# BULLETIN # 19

**PROJECT:** Harrison Recreation & Community Center – PHASE 2  
Harrison, NY

**RE:** Revised Walkway Pads above Corridor

**1 ROOF LEVEL PLAN**  
 1/8" = 1'-0"

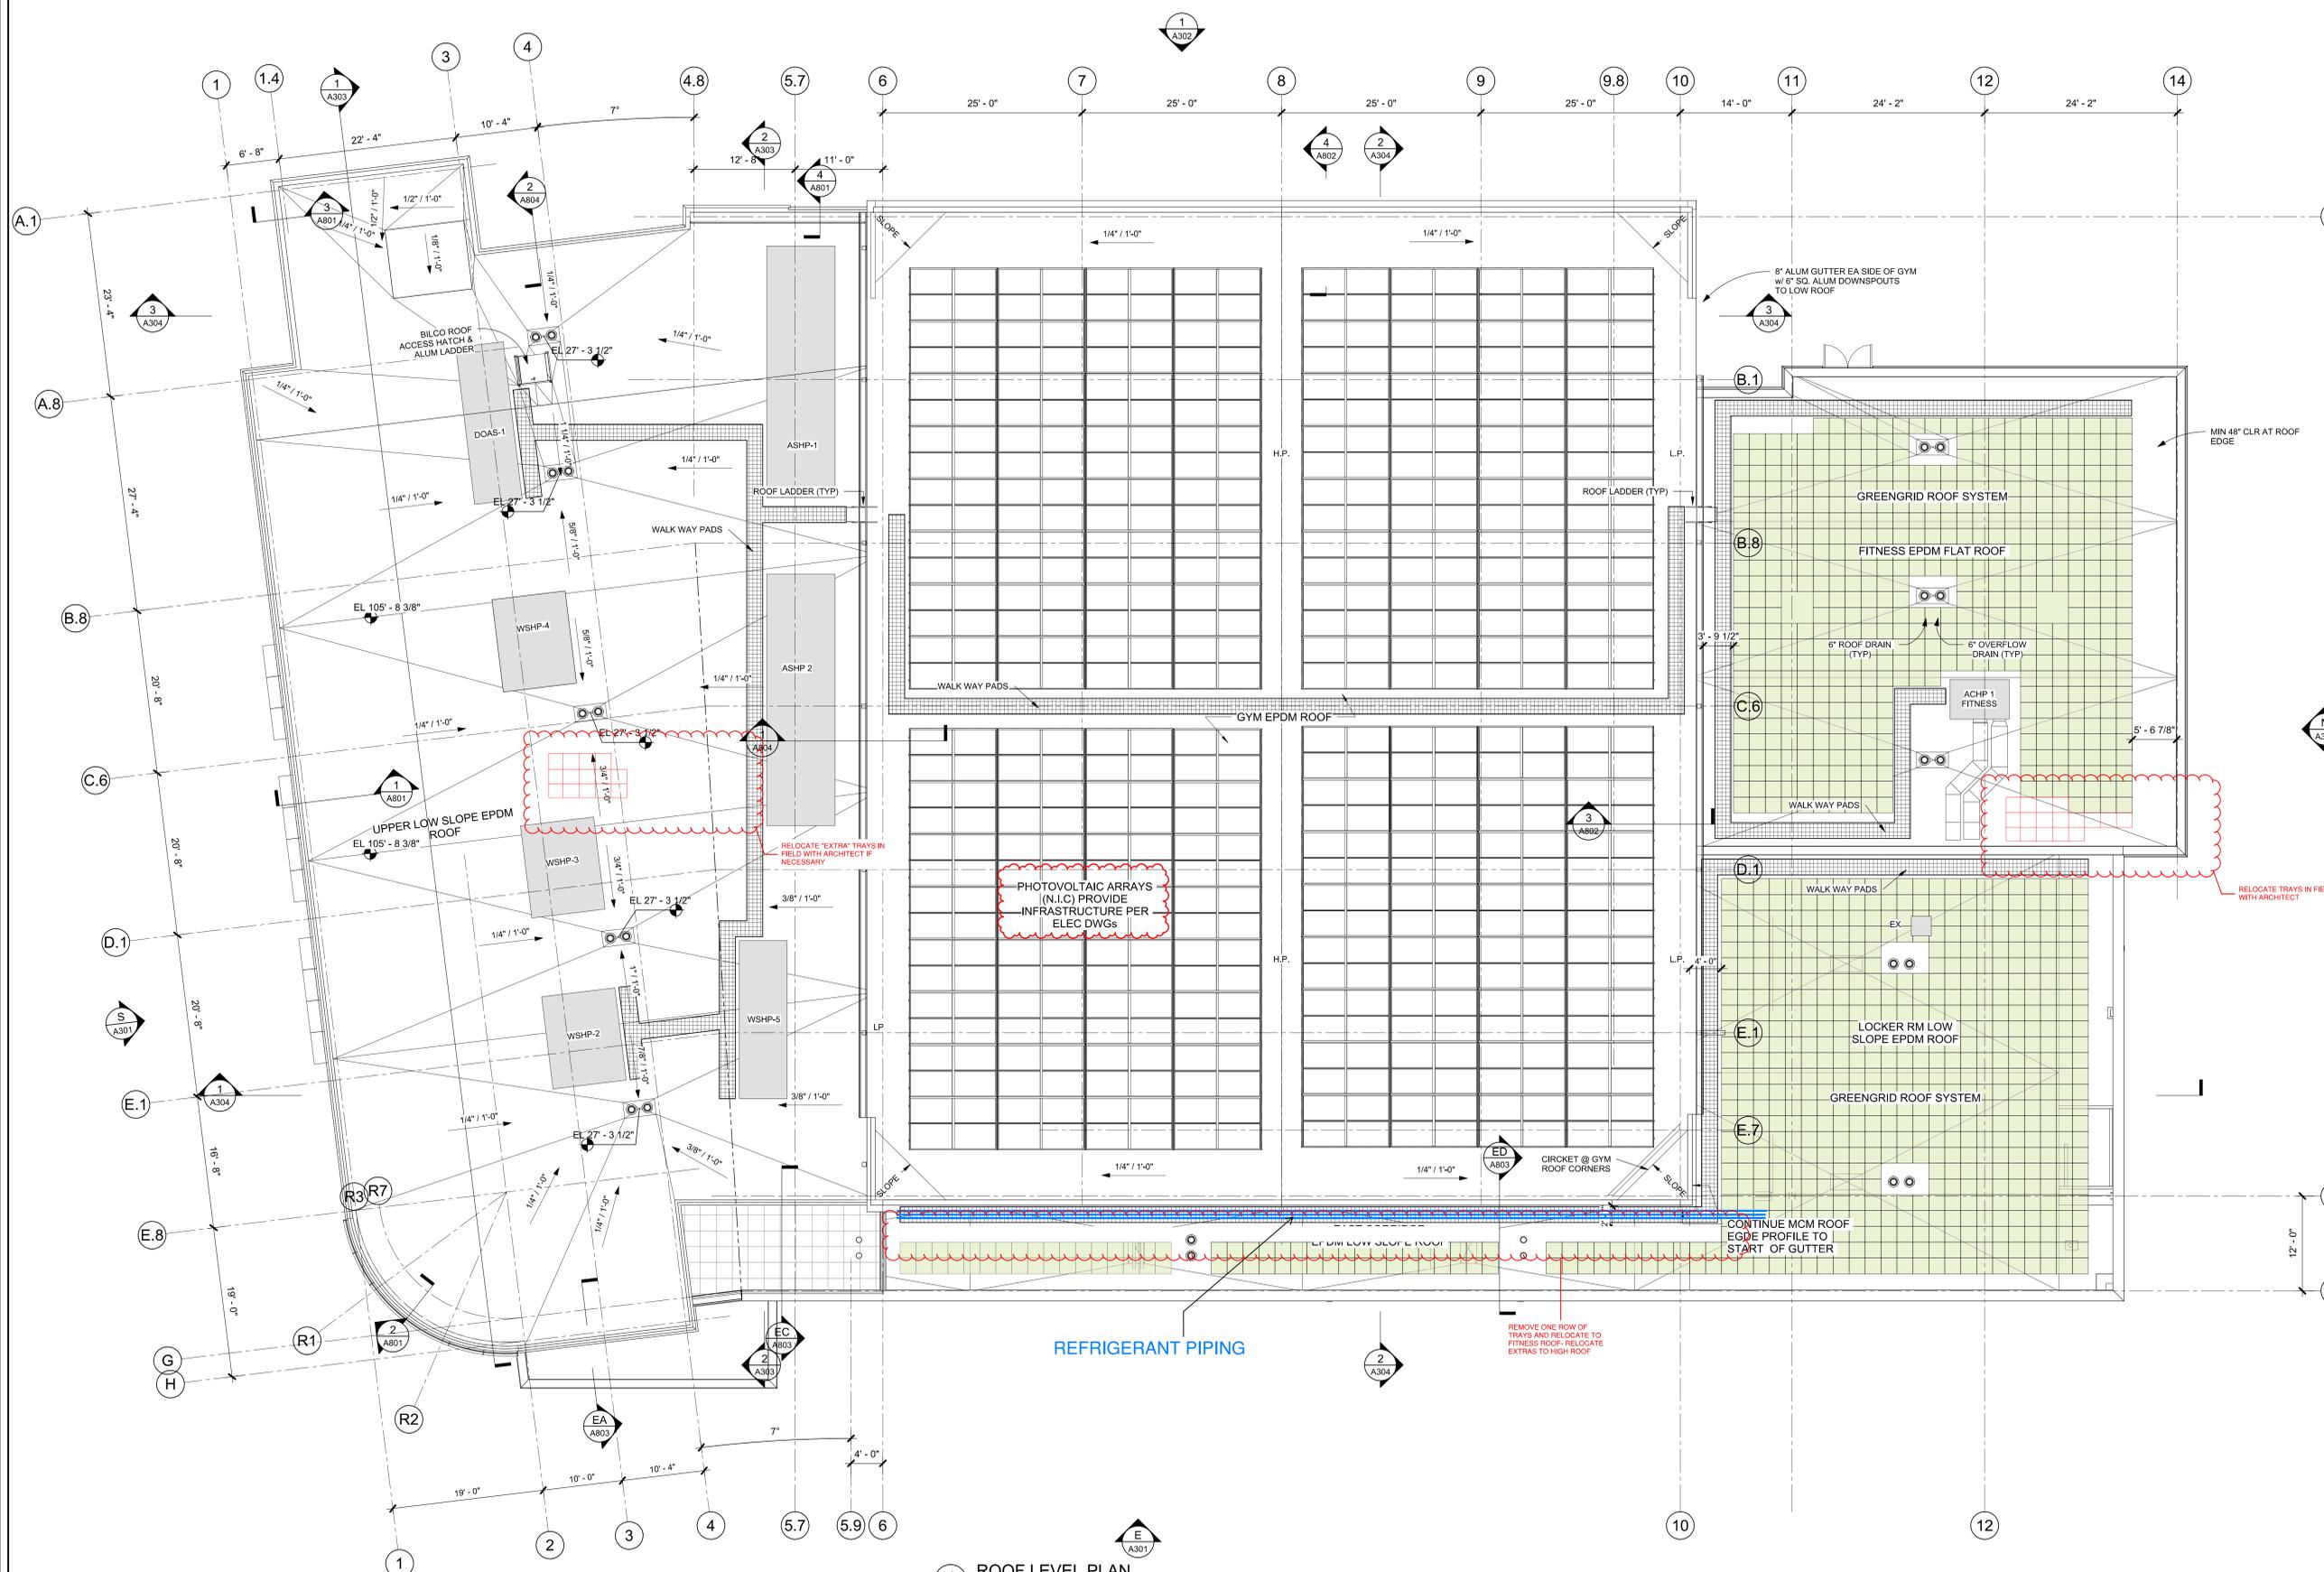
Please see the attached ASK-22 for the revised walkway pads at the Low Roof. Relocate vegetated roof trays to the Fitness Area roof to accommodate the refrigerant piping at the base of the Gym wall. Walkway pads to be placed where trays were removed at Corridor Roof.
